ADDENDUM No. 2

BID #5735

CABLE 27 STUDIO PHASE II

PARTIAL DEMO PLAN

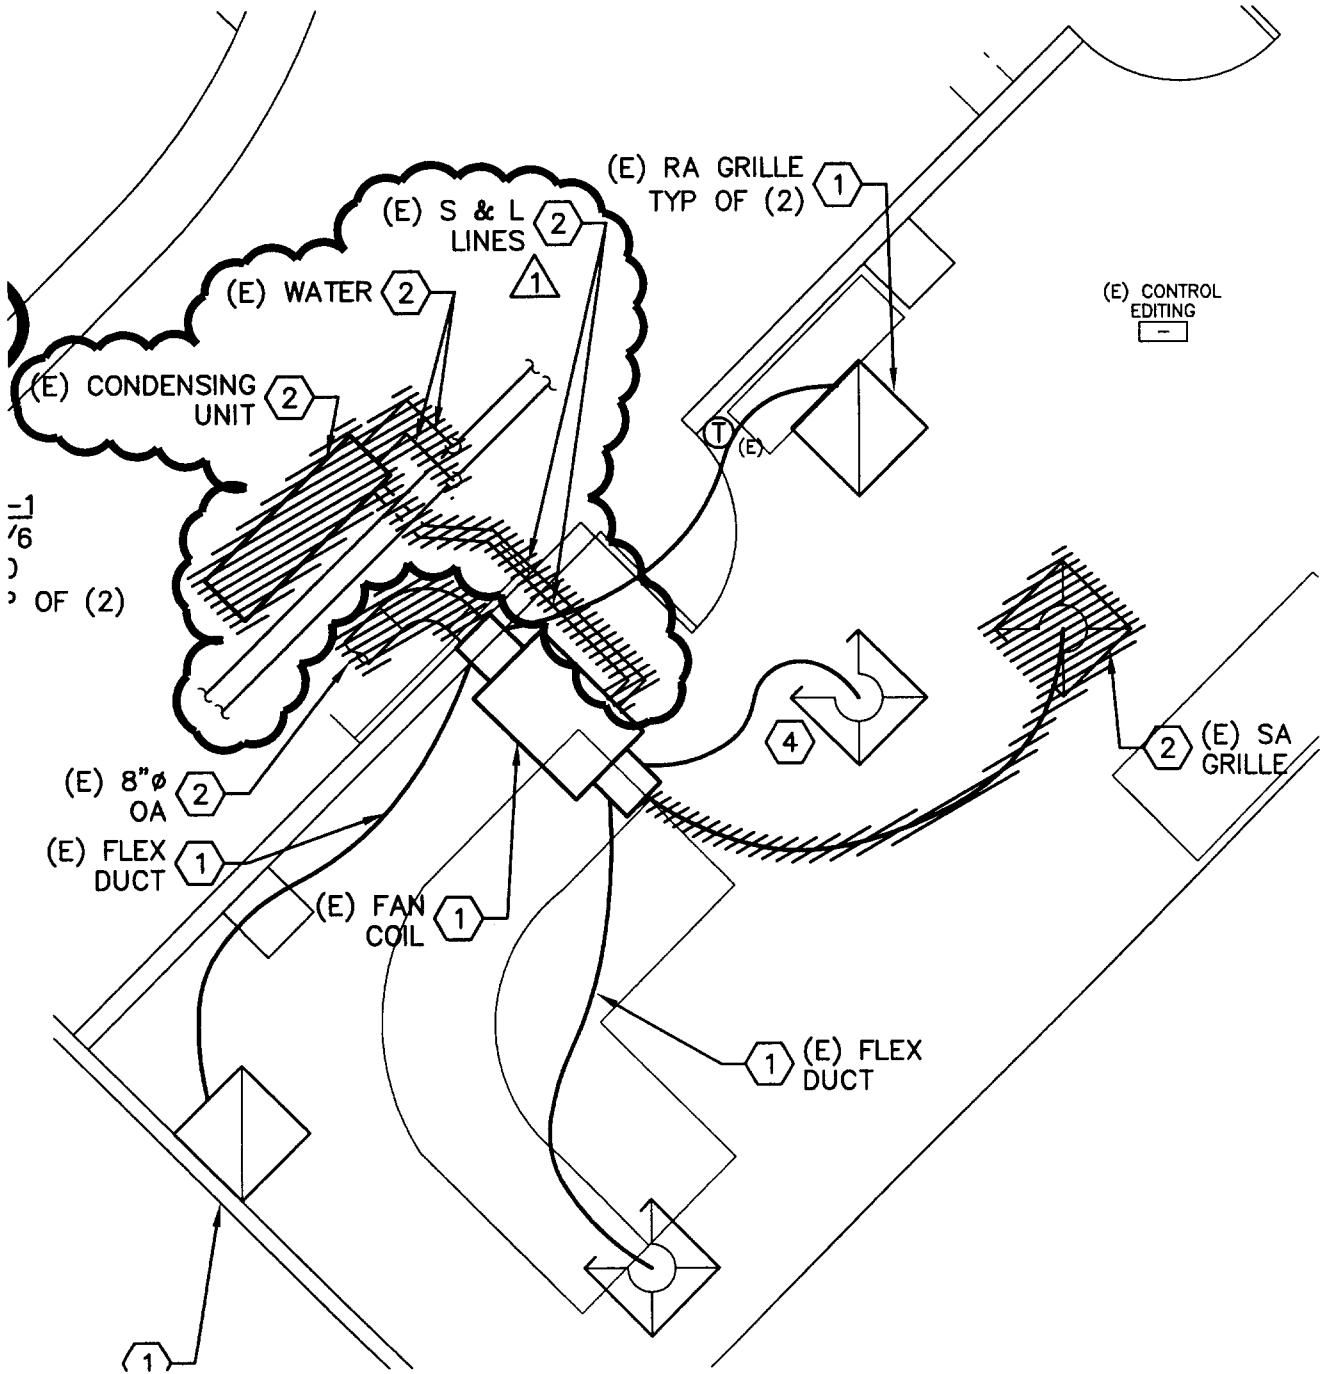
I. Sheet M1.2, MECHANICAL DEMO PLAN:

1. Demo existing Condensing Unit, Refrigerant Lines and Chilled water connections. See Sheet 1, PARTIAL DEMO PLAN.

PARTIAL MECHANICAL PLAN

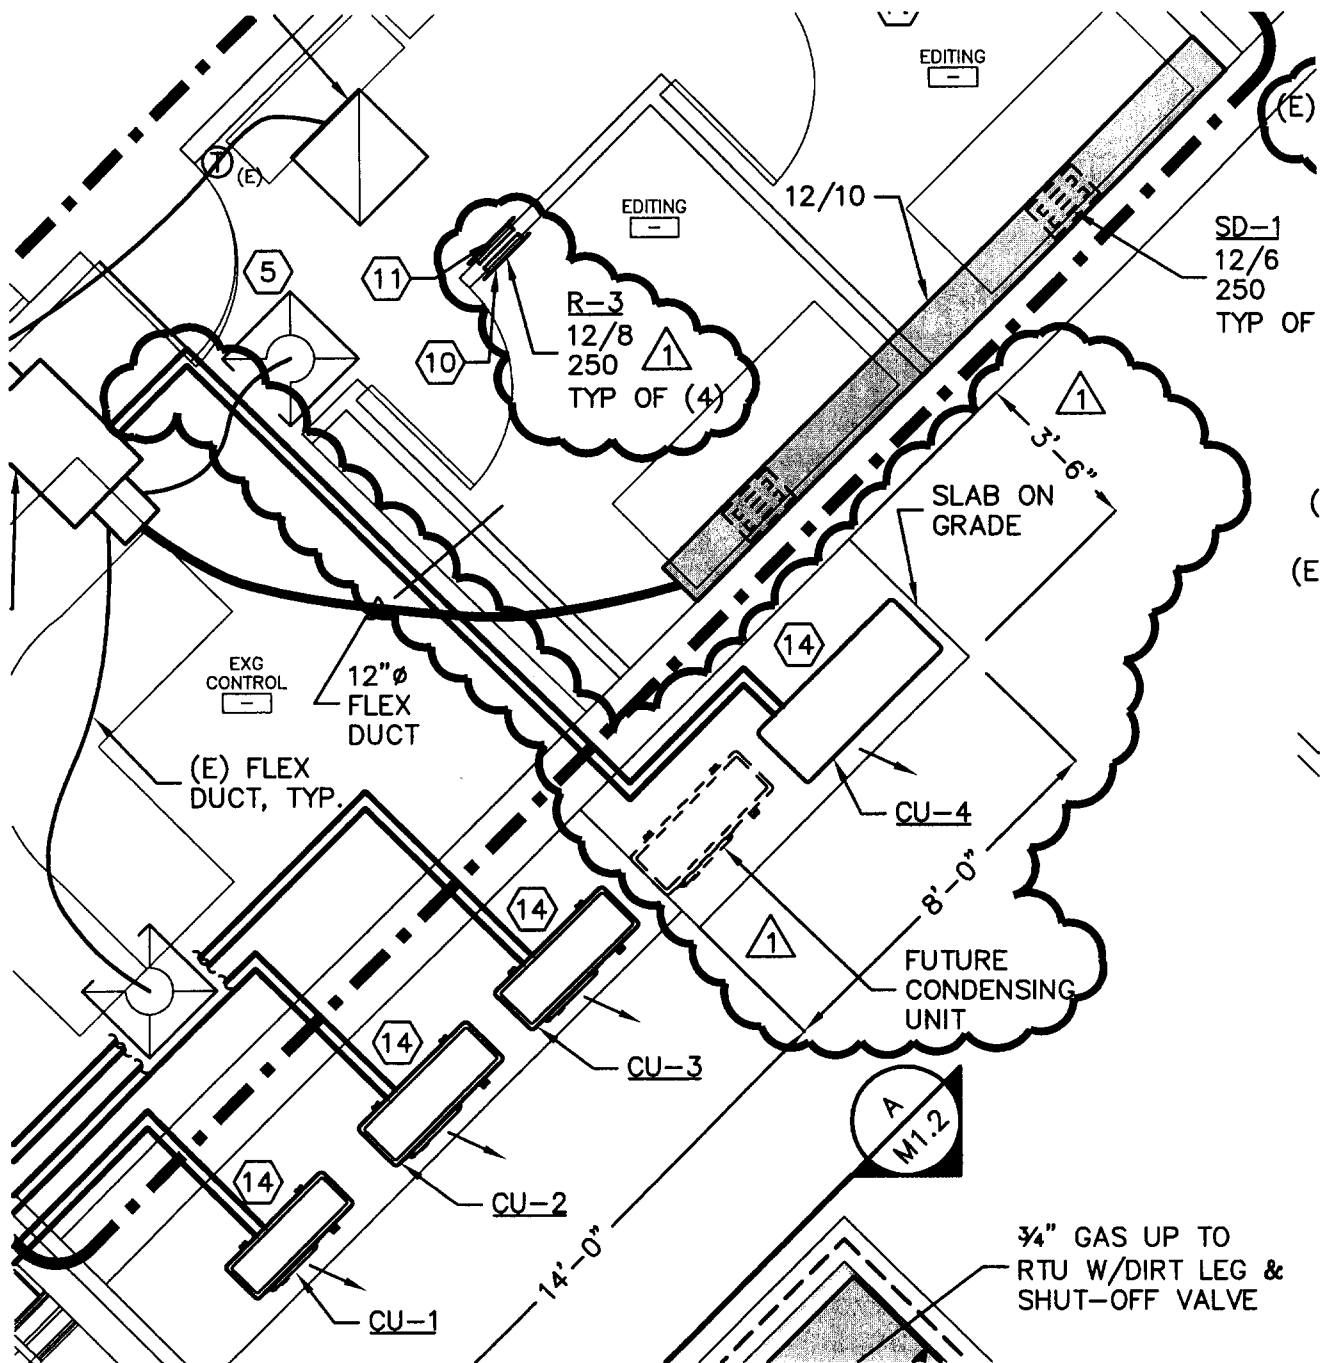
II. Sheet M1.2, MECHANICAL PLAN :

1. Add new refrigerant lines from existing fan coil, in existing Control room to new condensing unit. CU-4. Add area for slab on grade to set CU-4 and future condensing unit. Replace R-1 return air grille for R-3. See Sheet 2, PARTIAL MECHANICAL PLAN and Sheet 5, GRILLES REGISTERS AND DIFFUSER SCHEDULE and CONDENSING UNIT SCHEDULE.

PARTIAL MECHANICAL PLAN

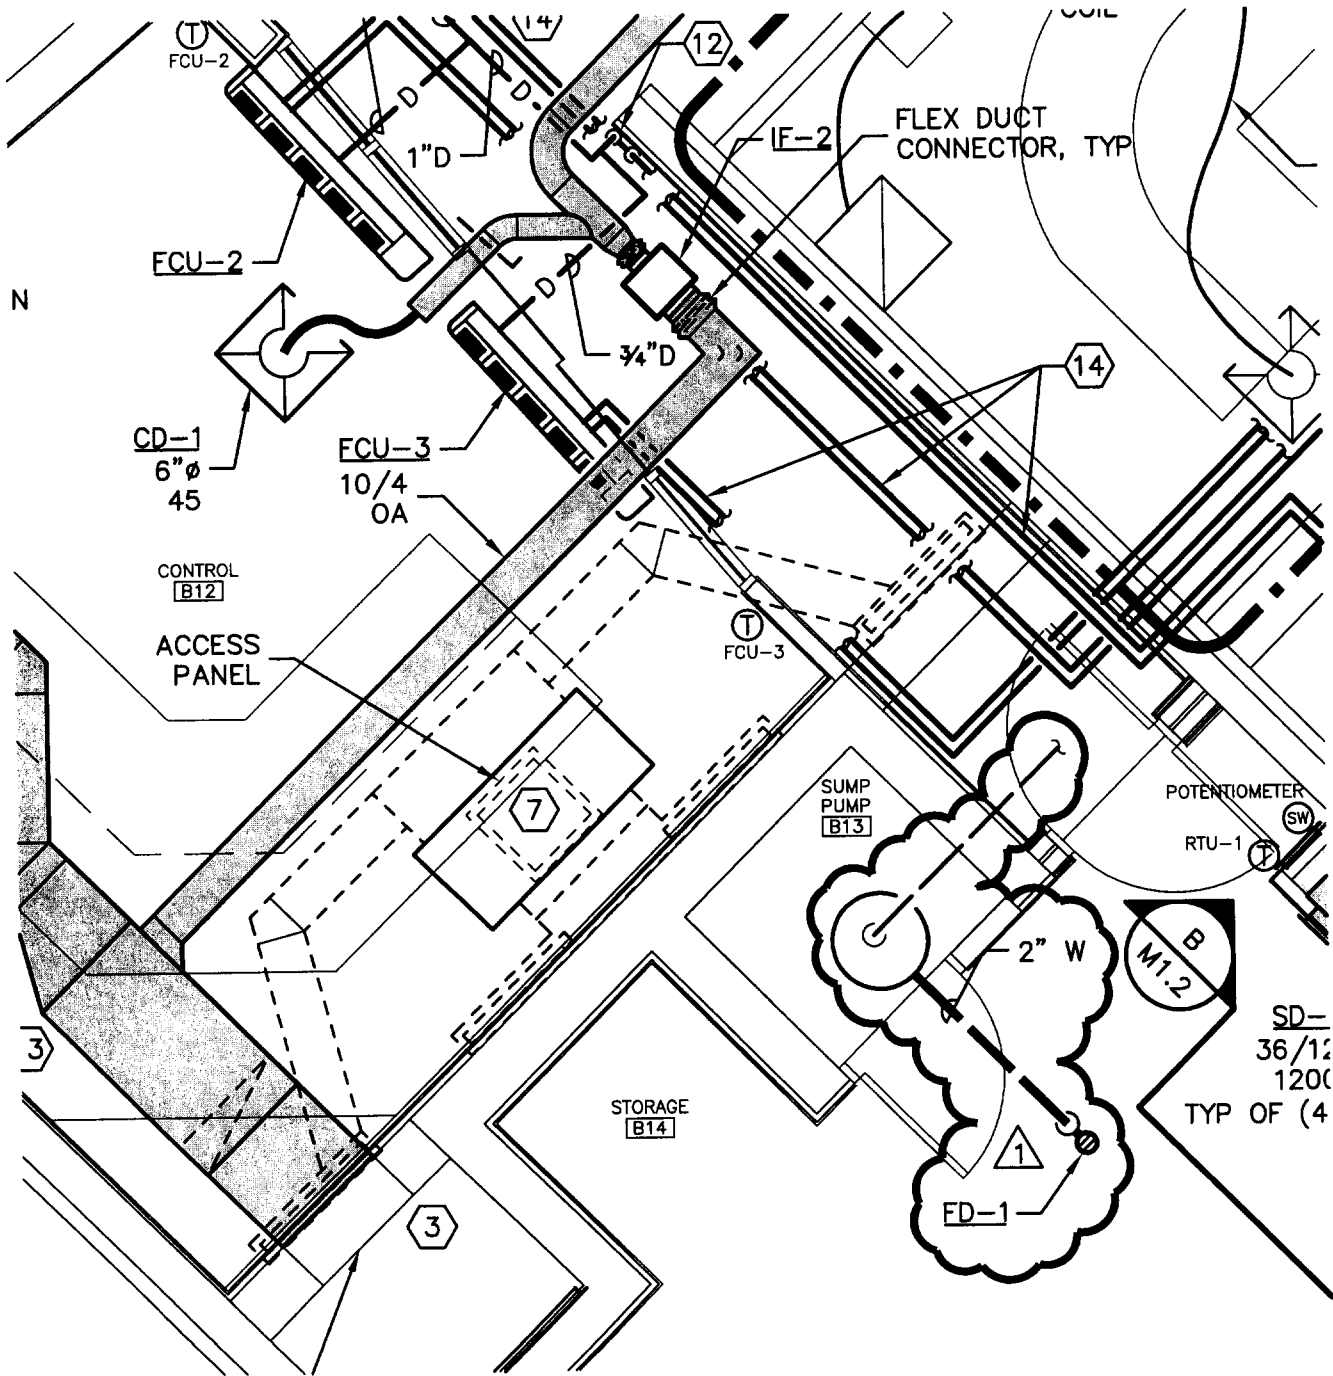
III. Sheet M1.2, MECHANICAL PLAN:

1. Add floor drain FD-1 and 2" waste line to existing sump pump pit. See Sheet 3, PARTIAL MECHANICAL PLAN. Change Flag Note 14. See Sheet 4, FLAG NOTES.
